PROPOSED AMENDMENTS TO THE DRAFT GTR
ON LIGHTING INSTALLATION

(TRANS/WP29/GRE/2001/6/Rev.4)

Transmitted by the experts from OICA

Passing situation (SUV vs. passenger car)

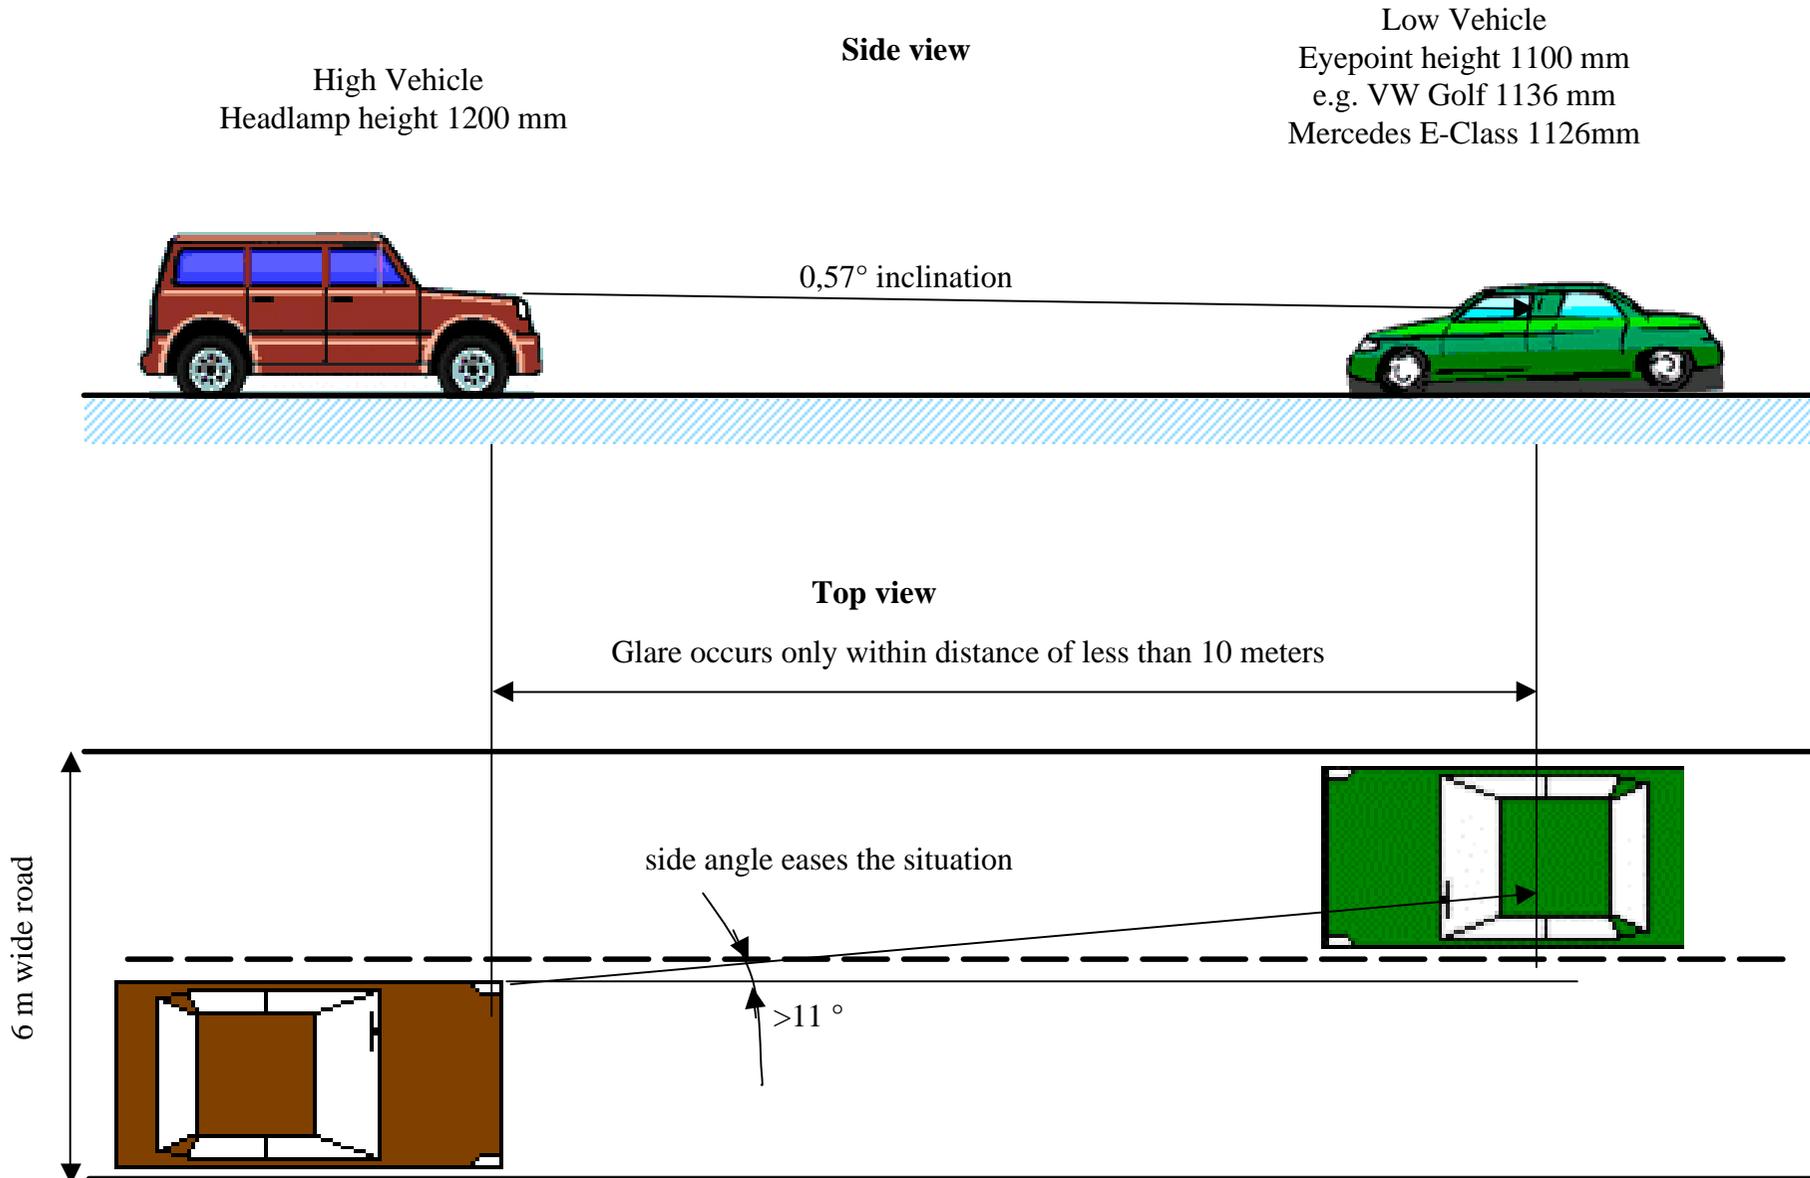
Paragraph 5.2.3.2: Proposed height requirements of 1200 mm for all passing-beam headlights

- The current height requirement for passing beam headlights is 1200 mm according to UN/ECE-R48 and 1372 mm according to FMVSS/CMVSS 108. The drafted height of <950mm for specific passing beam headlights is an artificially set limit without backup from research or comparable standards.

- The desire to reduce the headlight height is especially driven by glare discomfort issues in the North American markets. The proposed limit of 1200 mm is already a significant reduction in the admissible headlight height for these markets.

- The proposed headlight height of 1200 mm is the optimal match between active safety (visibility of pedestrians or obstacles) and glare discomfort. The average eye point height of passenger cars is 1100 mm to 1200mm above street level. With a 1% inclination (resp. $0,57^\circ$) of the passing beam, glare would occur at a time when the front of a car in ongoing traffic has a distance of less than 10 meters from the eye point of the driver and the driver turns his head by $>11^\circ$.

- Glare discomfort through the rear view mirrors can be reduced or avoided through manual or automatic day/night mirrors.

In height:

H2 more than or equal to 500 mm; and

H1 less than or equal to 1,200 mm.

Example of front side marker lamp positioning

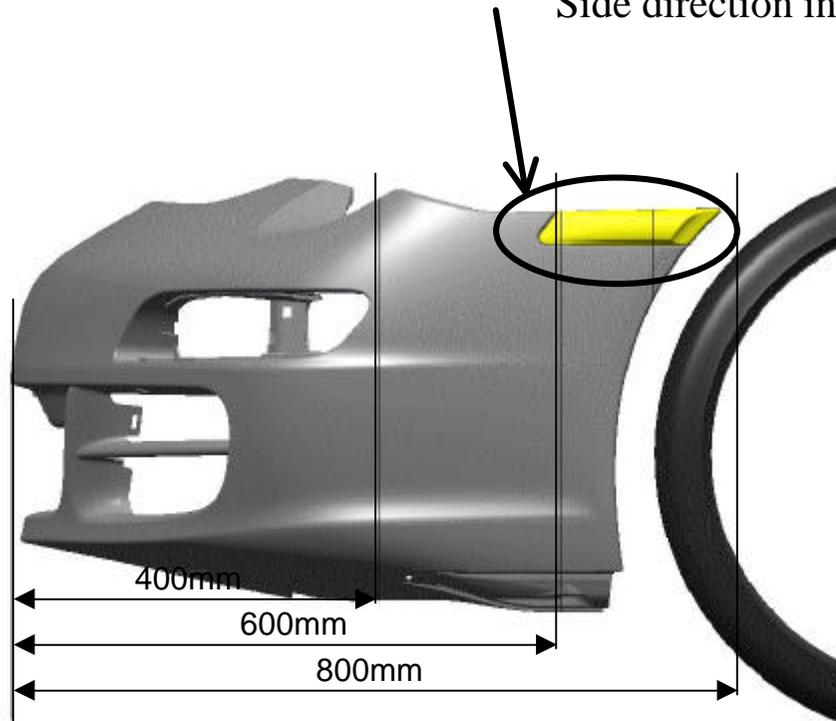
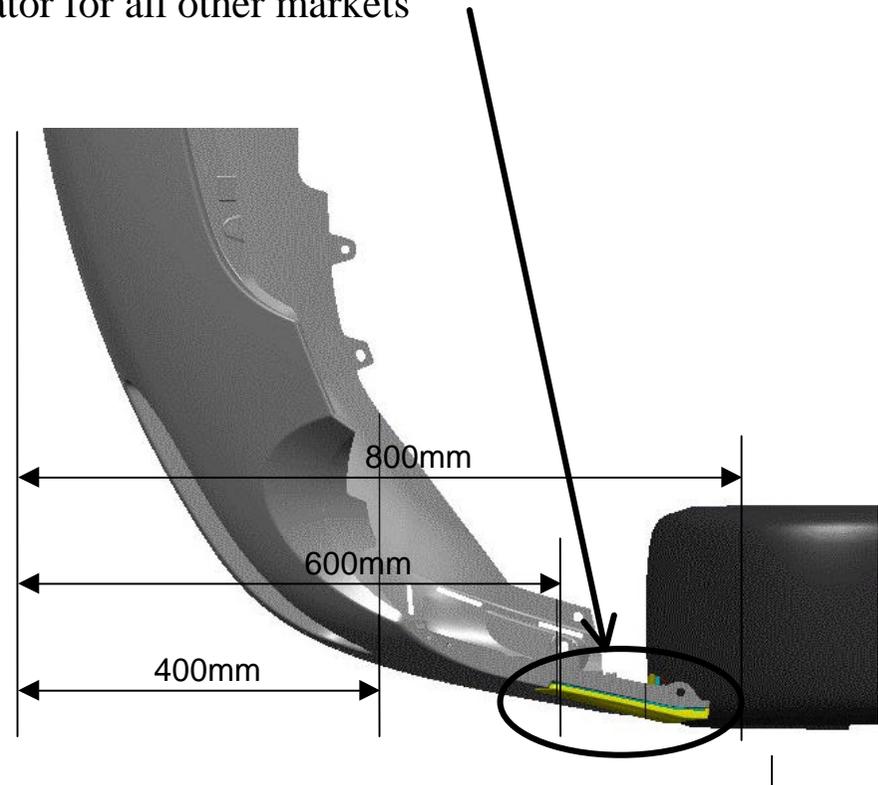
Paragraph 5.18.3.3: Proposed dimension "K" requirement of 800 mm for front side marker lamps

- The current requirement for the position of front side marker lamps according to FMVSS/CMVSS 108 is 'as far to the front as possible'. There is no requirement for this lighting function in Europe. The drafted dimension 'K' requirement of 400mm is an artificially set limit without backup from research or comparable standards.

- The desire for side marker lamps reflects the car design up to the 70's/80's with rectangular front ends having headlamps which were not visible when looking at a vehicle from the side.

- Today's, and even more future car designs show a significantly different style with rounded front ends to fulfill aerodynamics (fuel economy), pedestrian protection and city traffic handling requirements. To allow this beneficial design in the future, a dimension 'K' of <800mm is required.

- Given the requirement for the outboard horizontal visibility angle for front position lamps of $\beta_1 > 80^\circ$, the far front of a vehicle is already very well visible through the position lamp.

Replace the dimension K of "400 mm" by "800 mm".
